ENGINE – HP TURBINE ROTOR AND STATOR ASSEMBLY – NEW STAGE 1 HPT AIR SEAL – CATEGORY
CODE 7 – MOD.ENG-72-0111

V2500-ENG-72-0111

SERVICE BULLETIN

Location of Stage 1 HPT Air Seal
Fig.1

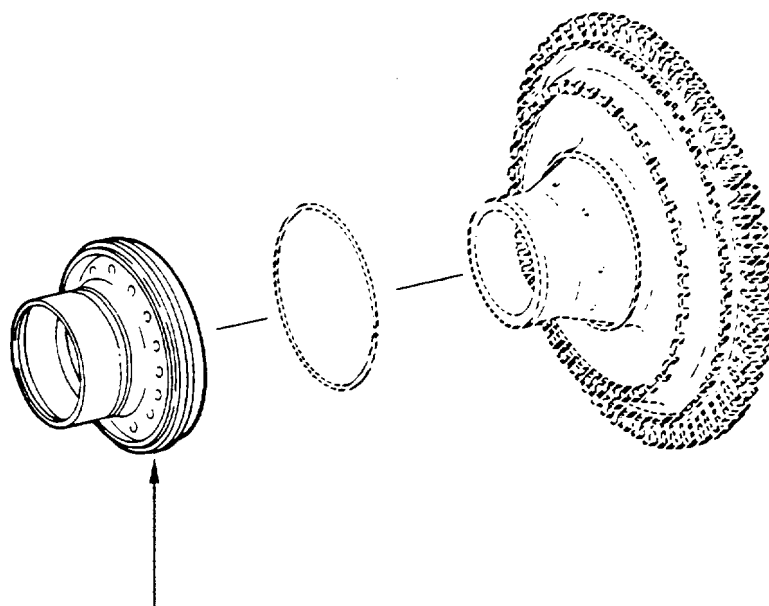
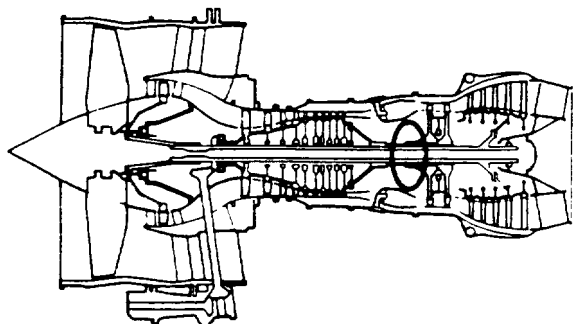
- (1) Replace the 2A0884 Stage 1 HPT Air Seal with 2A1203 Stage 1 HPT Air Seal, by the approved procedure in Reference (1), Chapter/Section 72-45-10, Assembly. See Figure 1.

INSTALL 2A1203 STAGE 1
HPT AIRSEAL (1 Off)

Family tree - Rotor and stator assembly HPT Module
Fig.2

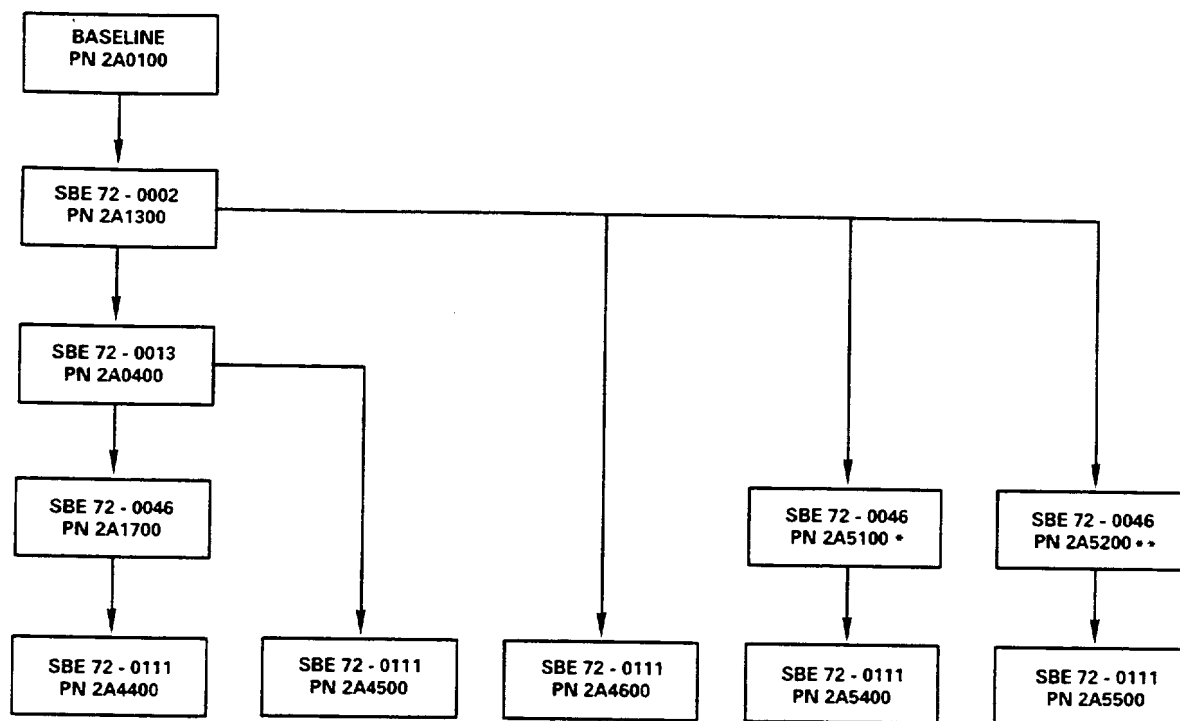
* FOR ENGINES NOT INCORPORATING V2500 - ENG - 72 - 0011

** FOR ENGINES INCORPORATING V2500 - ENG - 72 - 0011
